Model: PRIPORT Cats-eye	Date: 29-Mar-07	No: R-C269-002a
Subject: Firmware Modification History	Prepared by: K. Yamamoto, Priport Service Planning Section	
Classification:	<input type="checkbox"/> Troubleshooting <input type="checkbox"/> Part information <input type="checkbox"/> Action required <input type="checkbox"/> Mechanical <input type="checkbox"/> Electrical <input type="checkbox"/> Service manual revision <input type="checkbox"/> Paper path <input type="checkbox"/> Transmit/receive <input type="checkbox"/> Retrofit information <input checked="" type="checkbox"/> Other ()	
Model Name:		
Cat's-eye: Ricoh DX4640PD, Gestetner CP6340D, Savin 3585DNP2, Standard SD462, Lanier LDD350d

Model: PRIPORT Cats-eye	Date: 06-Sep-07	No: R-C269-005
Subject: Attachment procedure of the protection cover to tape dispenser type20		Prepared by: M. Kumagai, Priport Service Planning Section
Classification:	<input type="checkbox"/> Troubleshooting	<input checked="" type="checkbox"/> Part information
	<input type="checkbox"/> Mechanical	<input type="checkbox"/> Electrical
	<input type="checkbox"/> Paper path	<input type="checkbox"/> Transmit/receive
	<input type="checkbox"/> Other ()	<input type="che

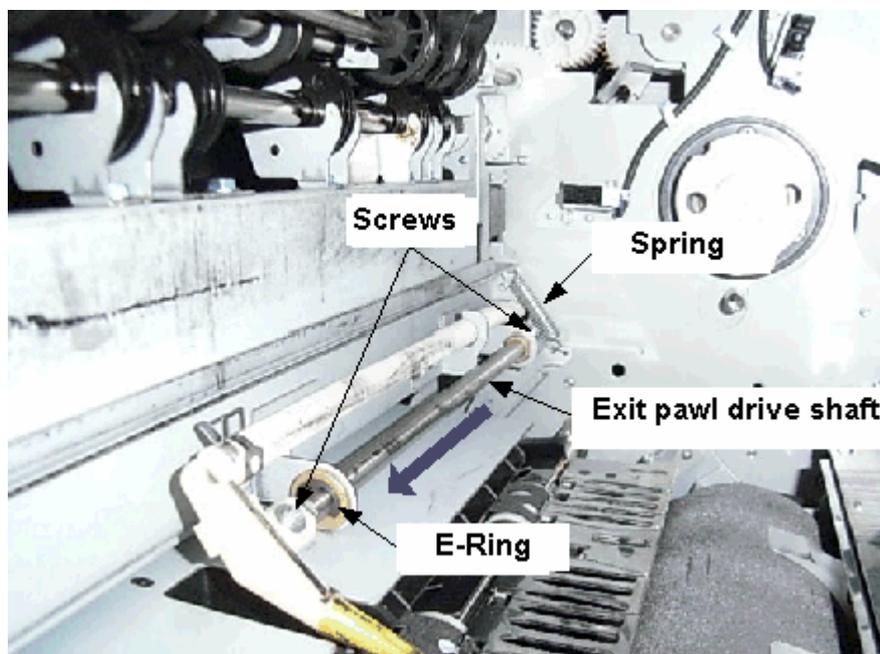
The shape of the exit pawl arm was changed and a hole was added, so that exit pawl does not touch the leading edge of the master.

Replace the exit pawl arm.

Important: Adjust the gap between the drum and exit pawl so that it is **1.5±0.3mm**.
See pg. 224-226 of the Service Manual for details.

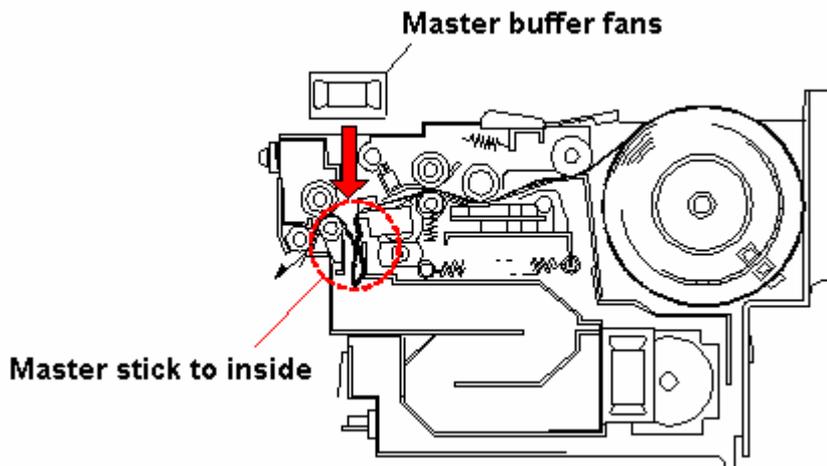
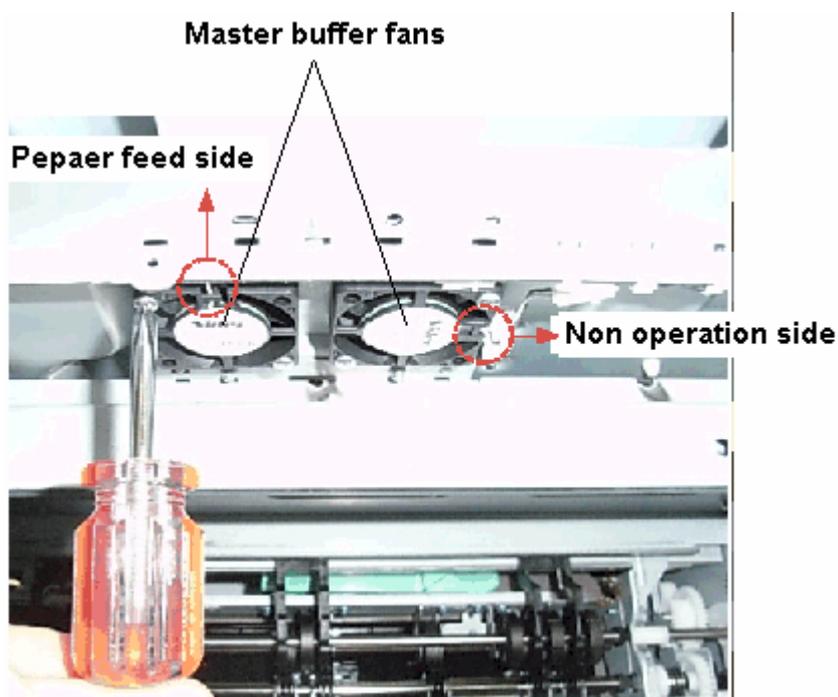
The master sticks to the inside of the master buffer duct.

Replace the master buffer fan.

Make sure the fan harnesses are facing the following directions:

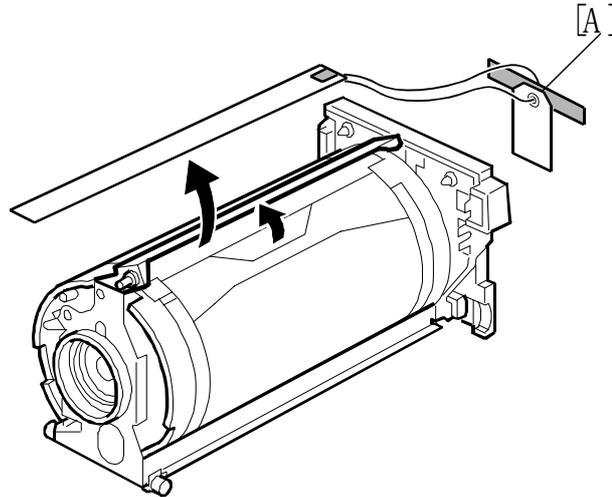
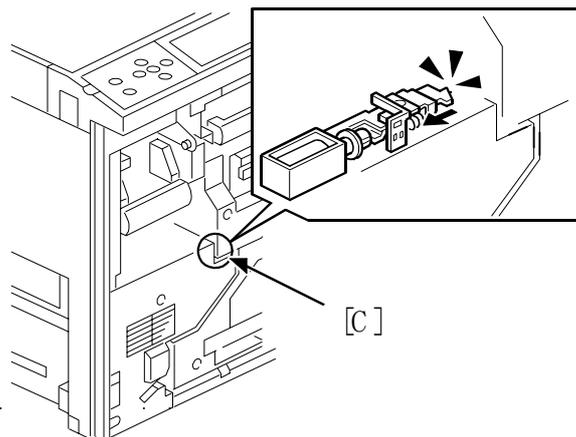
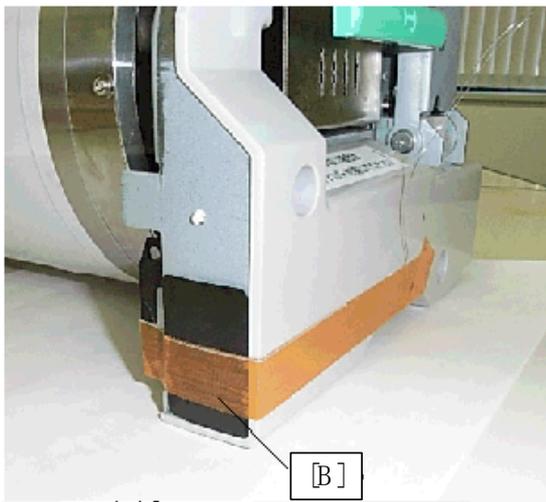
A master clamper error occurs during machine installation.

A drum clamber protection sheet [A] was added.

1. At machine installation, make sure to **remove this sheet before you turn on the main power.**
2. At machine installation, before you reattach the drum, remove the new Mylar [B]. The Mylar will release the drum lock release solenoid [C]. You do not have to use a screwdriver to release the solenoid.

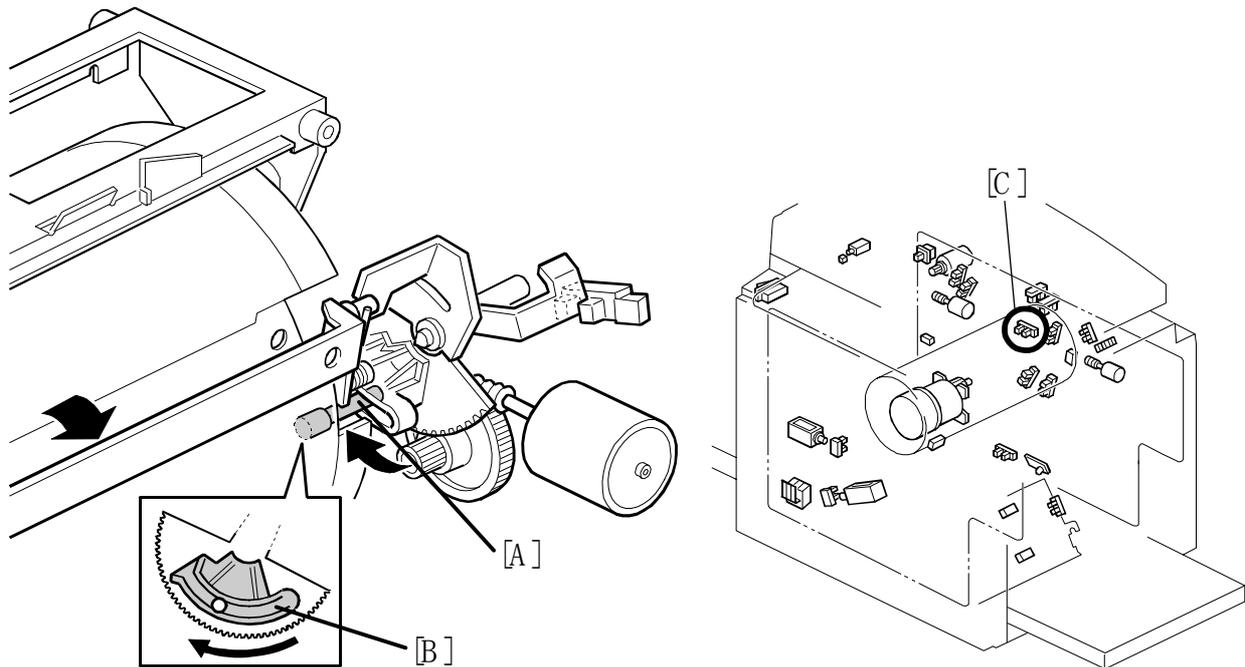
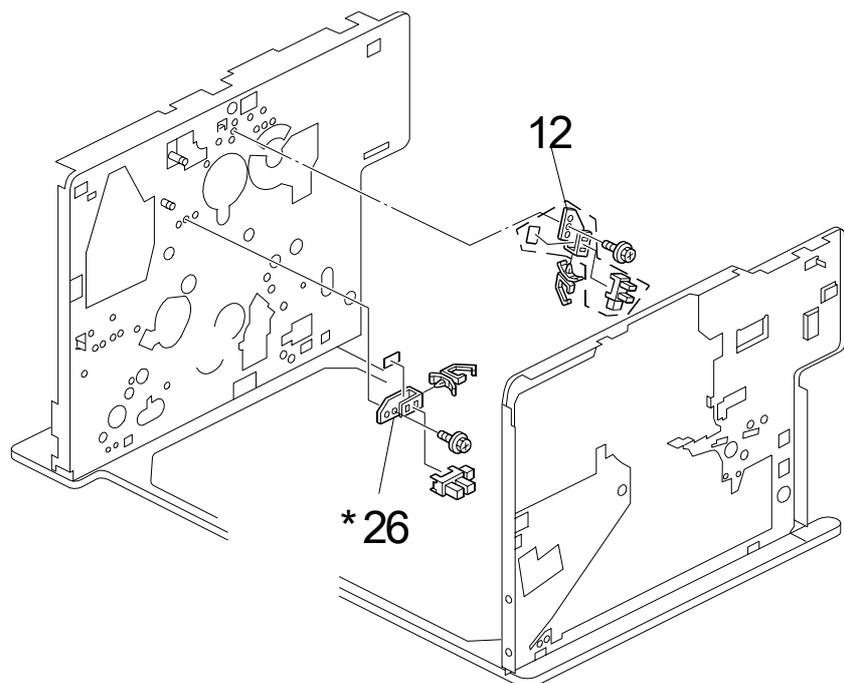
The drum does not stop at the master clamping position (2nd Drum Position Sensor [C]). As a result, the drum guide [A] cannot hold the drum stud [B].

If this symptom occurs on any of the following machines, replace the bracket for the 2nd drum position sensor (new P/N: **P/N C2699001**).

- There are two drum position sensor brackets (1st and 2nd). **Only replace the 2nd drum position sensor bracket.**
- Only replace the bracket on the target machines listed in this table.

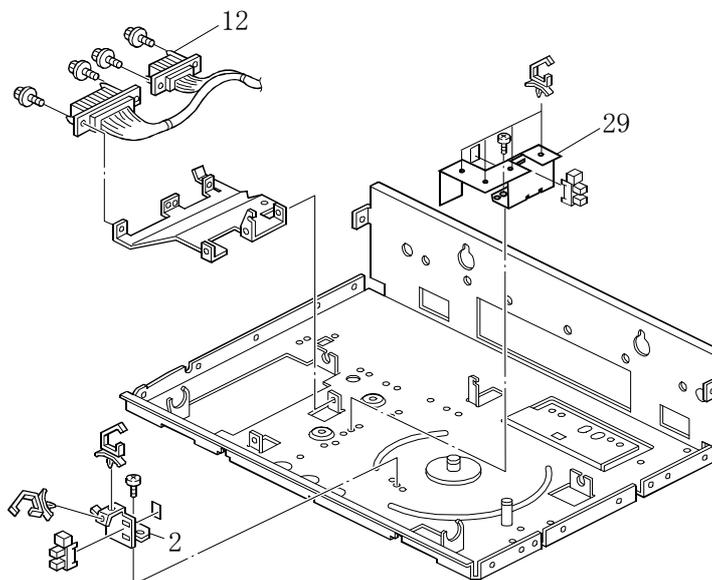
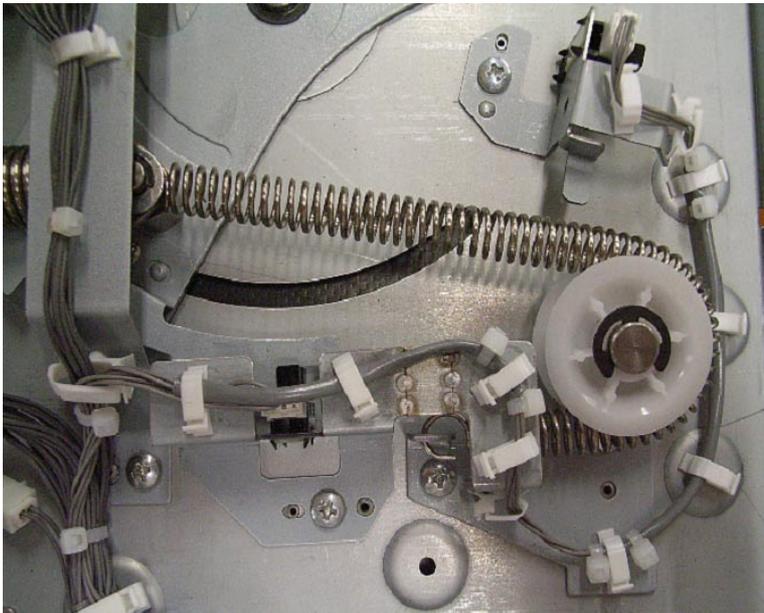
SC311/SC312 (Pressure Cam Shift Motor Lock) occurs.

Replace the harness [12] and sensor bracket [29] together as a set.

No.: RC269015

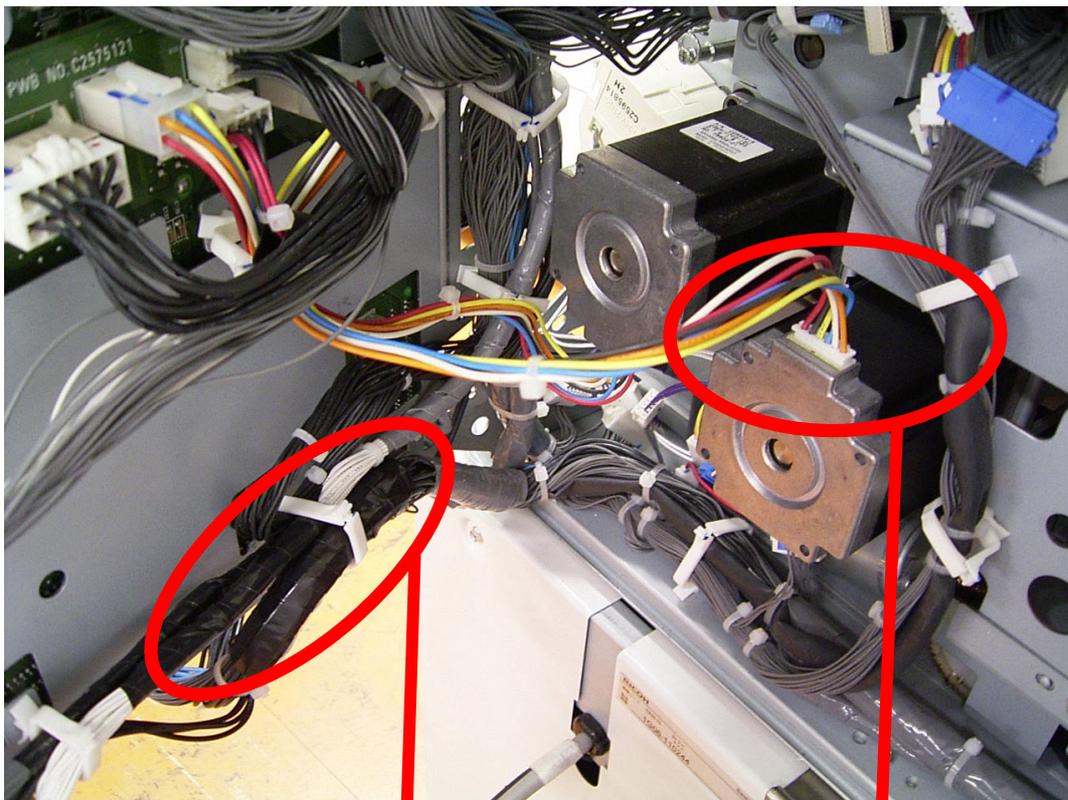
- The registration motor is now attached in a different direction so that the harness connector is at the top (180 degrees from its current position).
- Tape was added to the harness to further protect the harness.

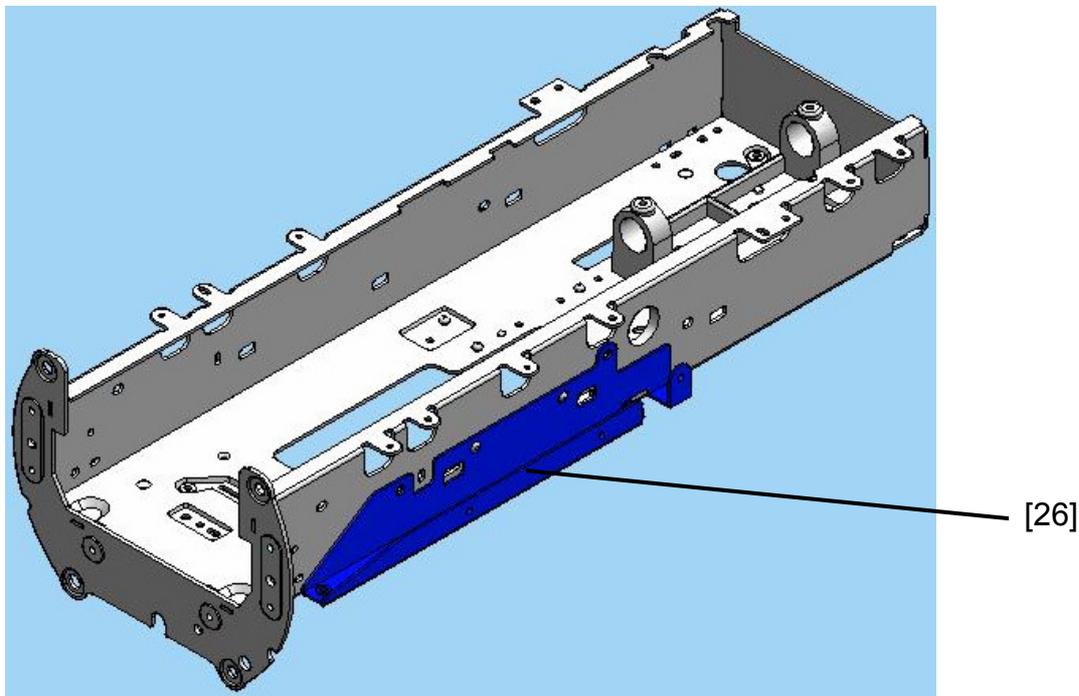
- 1) The material of the drum frame was changed.
- 2) As a result, the shapes of the frame and pins were changed and
- 3) A harness bracket was added.

Reason: To further increase the reliability of the drum frame.

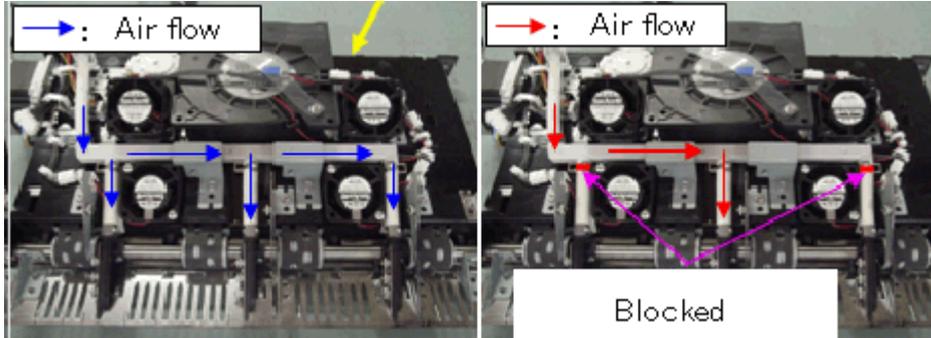
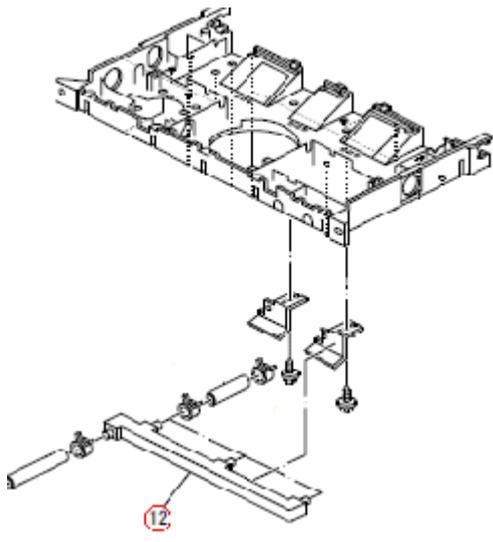
2. Two nozzles were blocked (the total number of nozzles is now one).

Old #	New #	Description	Qty	Int	Page	Index
C2693935	C2693975	PIPE:GATE:MIDDLE:ADHESION	1	X/O	41	12
C2693800	C2693801	HALE UNIT:ASS'Y (Paper delivery unit)	1	X/O	37	*

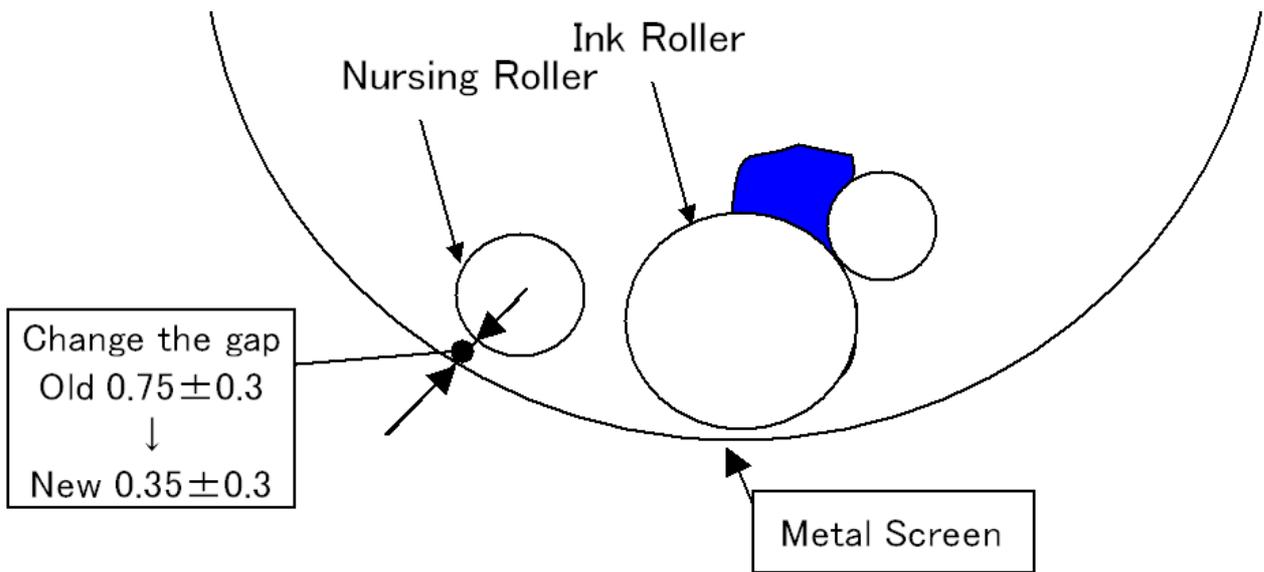
The shape of hole is changed

Change the gap
Old 0.75 ± 0.3
↓
New 0.35 ± 0.3
